IM3 (Jolie) Discrete 256M & UMA Block Diagram

Title: Schematic Block Diagram

Size: Document Number IM3 (XPS-Jolie) Rev 2A

Title: SYS 5V/3V(MAX17020)

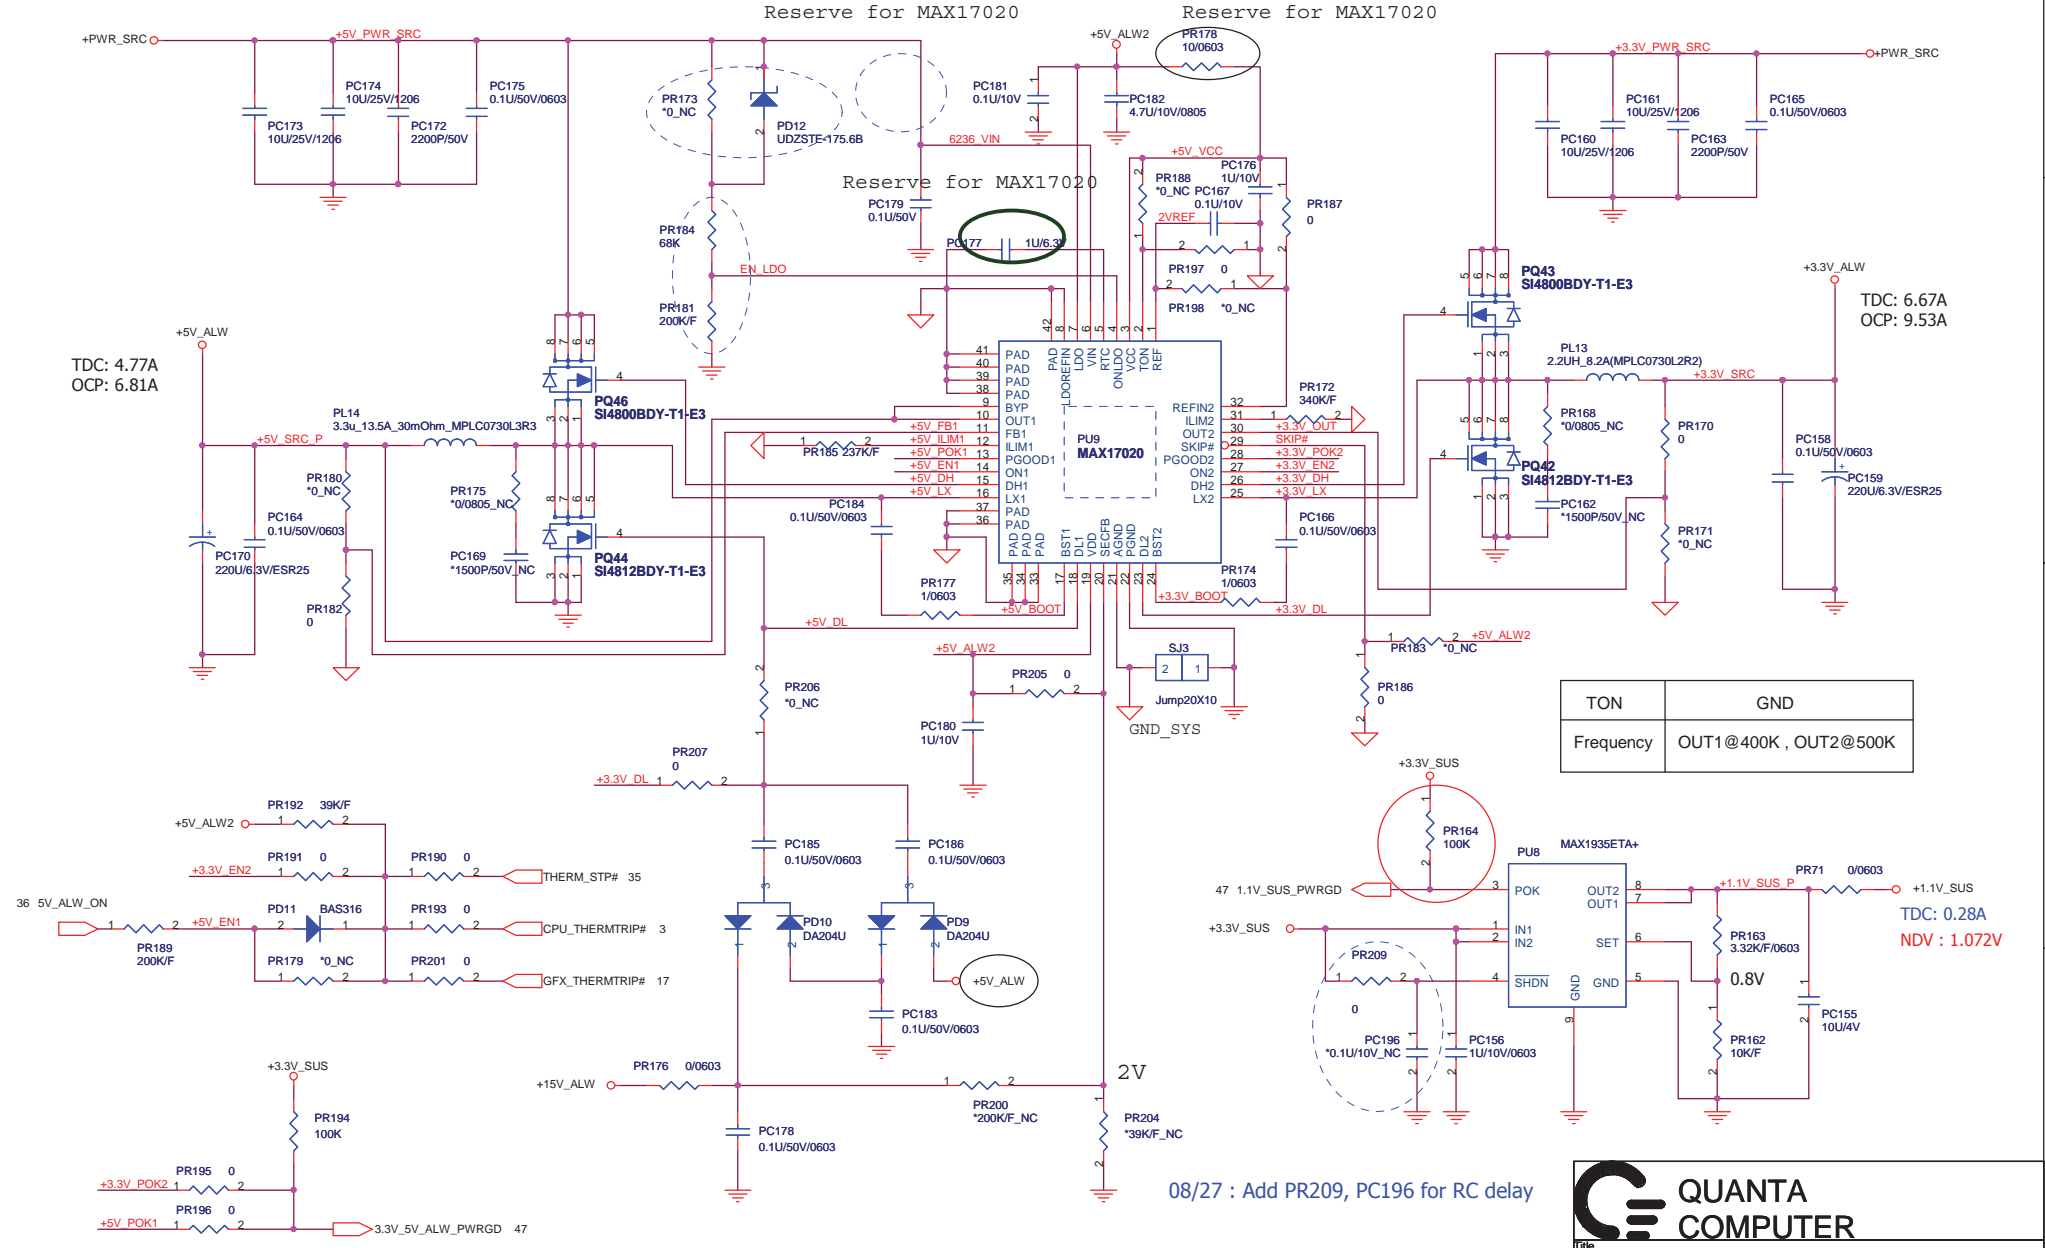
08/27 : Remove PR169, PR173 (0 ohm)
 08/27 : Add Zener Diode (PD12), PR173 and change PR184=68K, PR181=200K to fix +3.3V_ALW glitch issue when adapter unplug

0916_Rick:Change PC177 value from 0.1u to 1u

08/27 : Add PR209, PC196 for RC delay
